CORRESPONDENCE
FILE.

NOTICE UNDER SCHEDULE VI CHAPTER XI, RULE 2 (I) OF
THE CITY OF KARACHI MUNICIPAL ACT 1933.Karachi 14. 7. 36.

PLAN SHOWING PROPOSED BUILDING ON

PLOT NO. 15 & 16 SHEET NO. M. M. 7

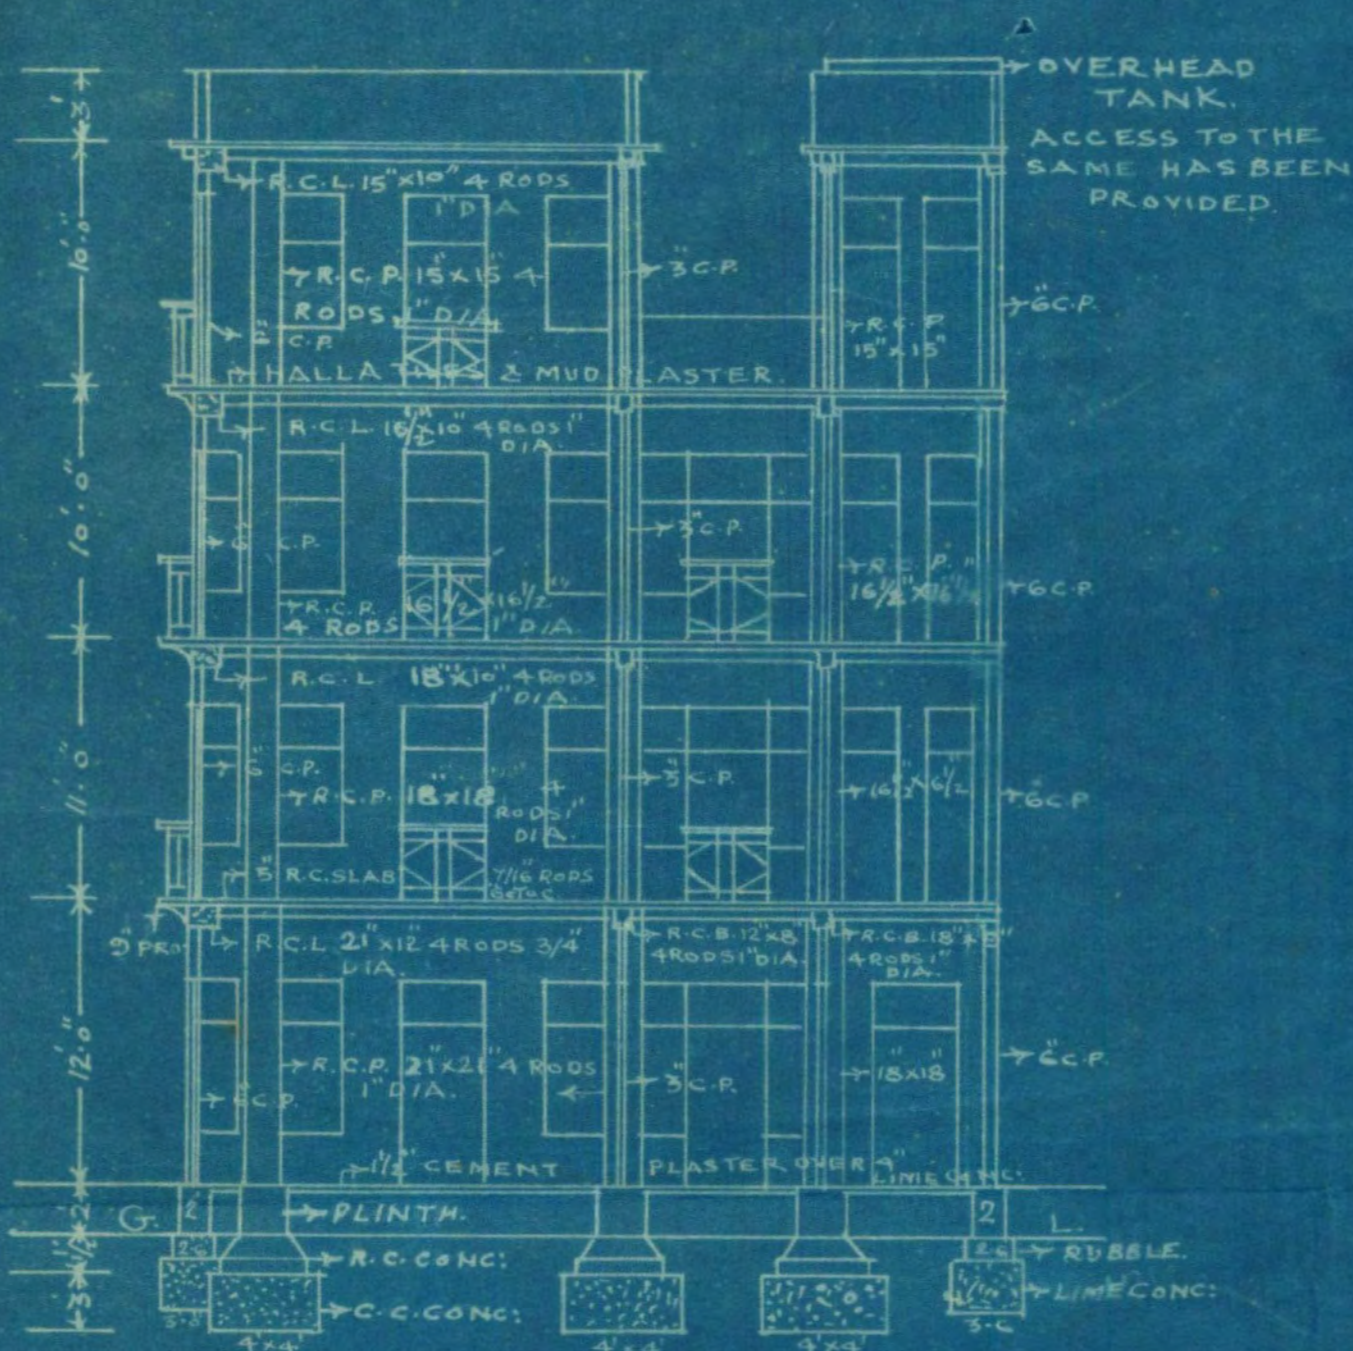
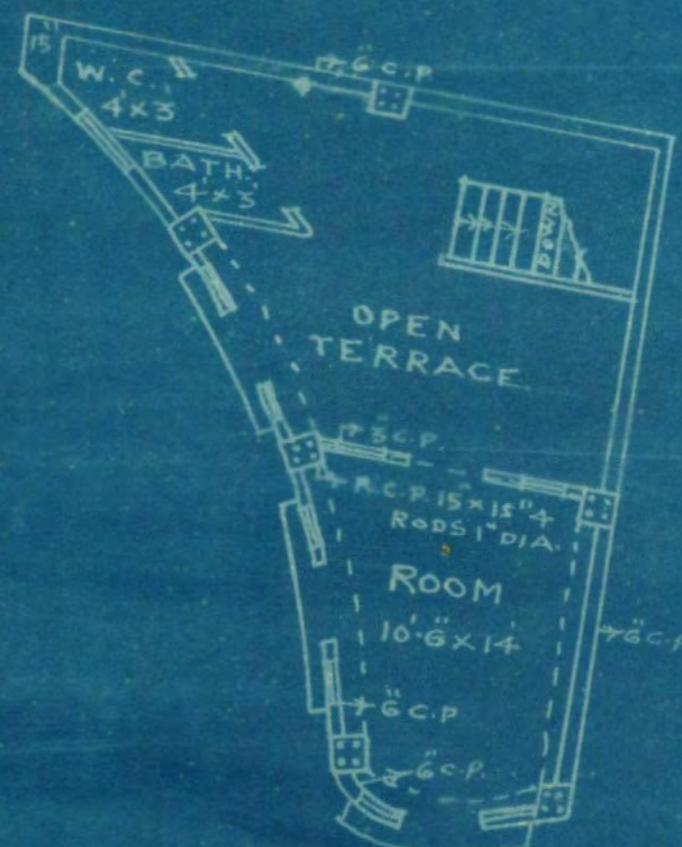
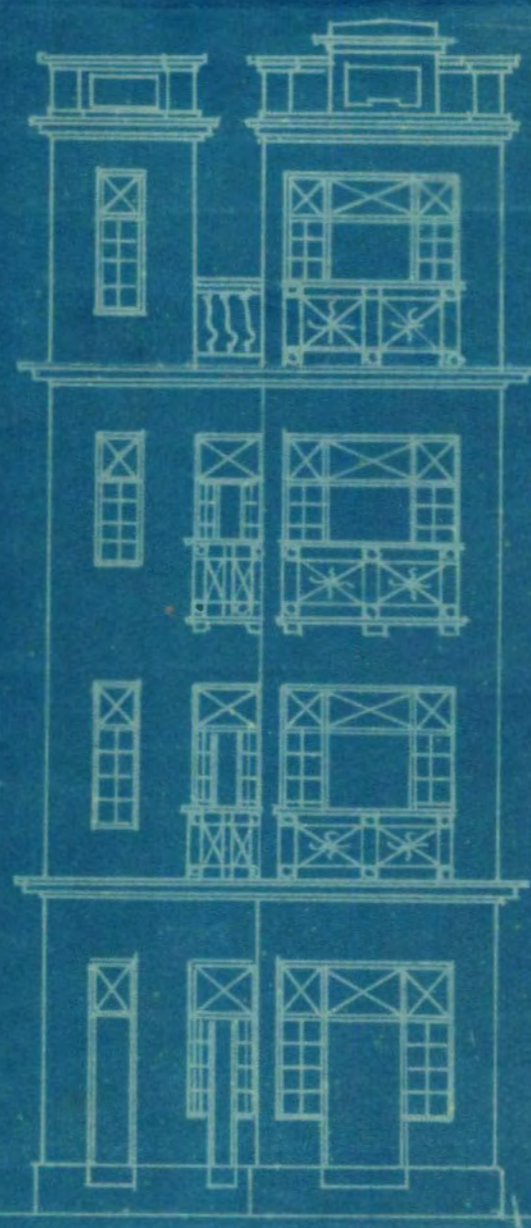
No through ventilation

1. W.C marked x is against rules.
2. U. G. & O. I. tank should be 2 ft away from the adjoining Owners wall.

1. (a) Does the plot come under Alignment? yes + also some portion of land is available for grant, was granted already -
- (b) If so, is the street line correctly shown? -
2. (a) Does the plot come under the T. P. Scheme? -
- (b) If so, is the plot shown as finally re-constituted? -
3. (a) Is there any encroachment? - No. 16/7/36?
- (b) If so, state the nature and No. of sq. yards? -
4. (a) Is the area of the plot stated on plan correct? - No.
- (b) If not give the correct area. -
5. (a) Is the plot subject to any conditions of previous sub-division and amalgamation? -
- (b) If so state the conditions. -
6. (a) Is the street width correctly shown? yes
- (b) If not state the widths. -

(1) Plot Nos. 16 + 16 require amalgamation.

(2) Land coming under alignment must be put back as shown on site plan.

(3) Total area of plots require to be shown.

- 1: W.C on G.F is against the rule.
- 2: Width of Street does not permit of ^{Third} ~~fourth~~ floor, which must be deleted.
3. Plans can only be finally approved after the plots are amalgamated
4. Kitchen will be dark 30/7

1. Windows have been provided for through Ventilation.
2. Position of W.C on ground has been changed.
3. These have been shown.
4. Plans for amalgamation have been submitted
for approval to the C. D. C.
5. Plans have designed in such away that
the land has been set back.
6. Area is shown in the plan.
8. Width of street is 30 ft according to which
a Room is allowable on the top and the total
height comes to 45' feet.

10. Wall between the kitchen and the verandah
will be 7 feet high ~~outside~~.

SITE PLAN

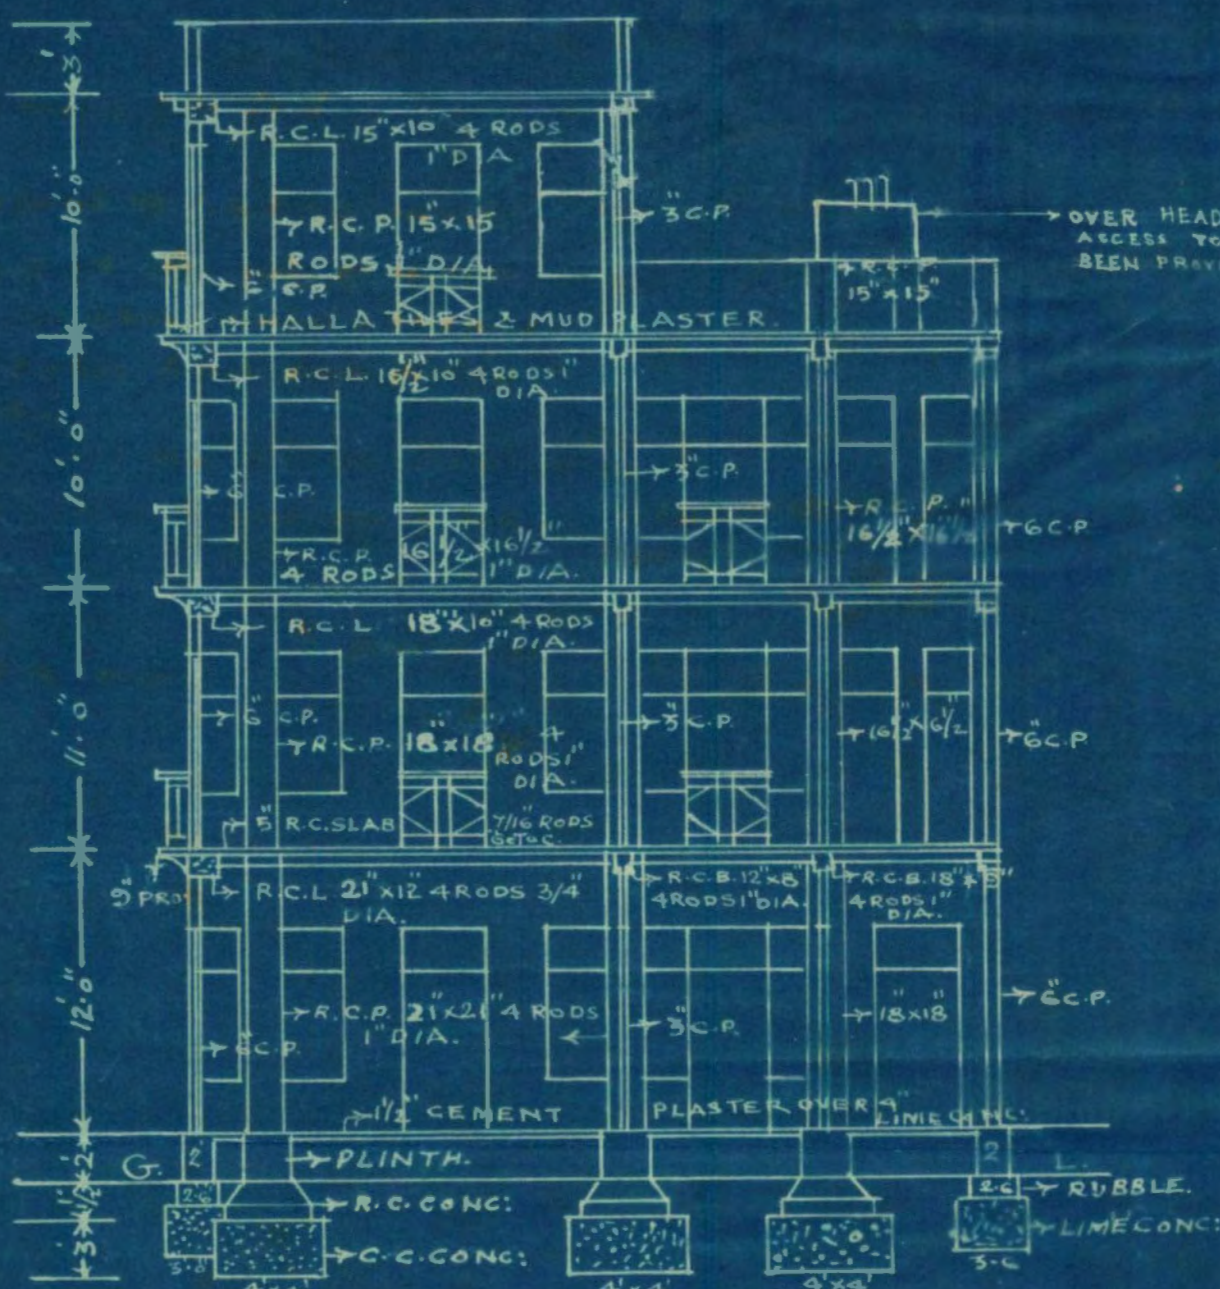
The amount of area to be granted and again
must be stated by computation by scale.

B. ~~What~~ Please report width of the str. at A - The width of the Phawar St is not applicable in this case.

3 & 4. The alignment is sanctioned and the area acquired is much more than the area granted. As therefore my client is to receive compensation for the land instead of giving anything for the grant there should be no objection in approving the plans.

Chief Officer's order for allowing construction on the land to be granted the being obtained. The height of the building must be regulated according to the street exactly in front and not Phawar St.

SECTION ON A.B.

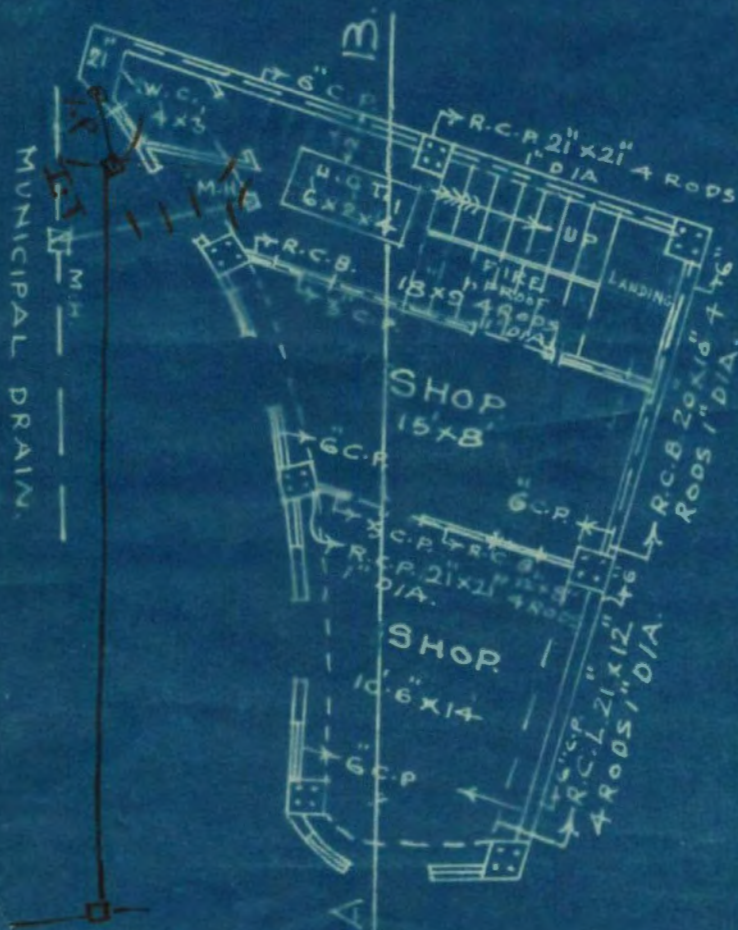
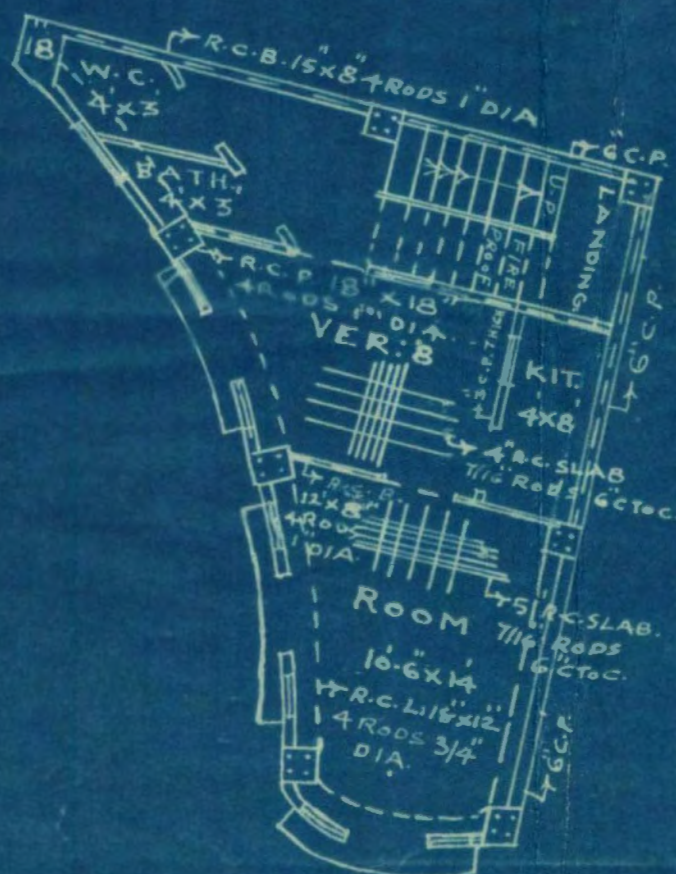
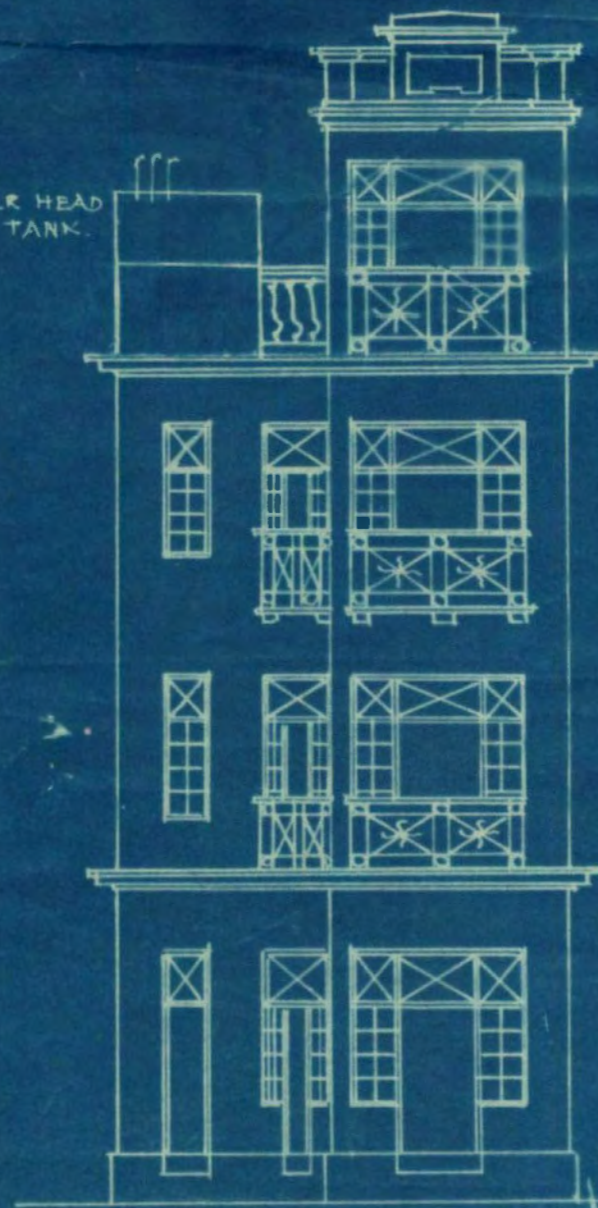
1. No through ventilation is provided.
2. W.Q. marked X is against rules.
3. Underhead ground and overhead tank should be 2 ft away from the adjoining owners wall.
4. Plots require to be amalgamated
5. Land coming under alignment must be set back as shown on site.
6. Total area of the plot require to be shown.
7. W.C. on ground floor is against rules.
8. Width of street does not permit of third floor which must be deleted.
9. Plan can only be finally approved after the plots are amalgamated.
10. Kitchen will be dark.

1. There is no thorough ventilation, in the building.
2. Requirements no. 1, ⁴8 and 9 of this office letter dated 4-8-36 remain to be complied with.
3. The amount of area to be granted and acquired must be stated by computation by scale.
4. Permission to build over area to be granted can only be given after the grant of such area to the owner.

1. The Chief Officer's orders for allowing construction on the
the land to be granted are being obtained.
2. The height of the building must be regulated according
to the street exactly in front and not Thanwer street.

1. From the site plans it will be seen that the plot is open on two sides having roads on them & is closed on the other two sides by plots. ^{height of Street width to be considered is 30 ft and therefore are} ~~height of~~ ^{building is allowable.} 2. Plans for the amalgamation of plots ~~is~~ ^{are} sub-
~~mitted~~ ^{mitted} to the C. D. C. for approval.

2. The top floor has now been deleted so as to
reduce the height to 33ft.
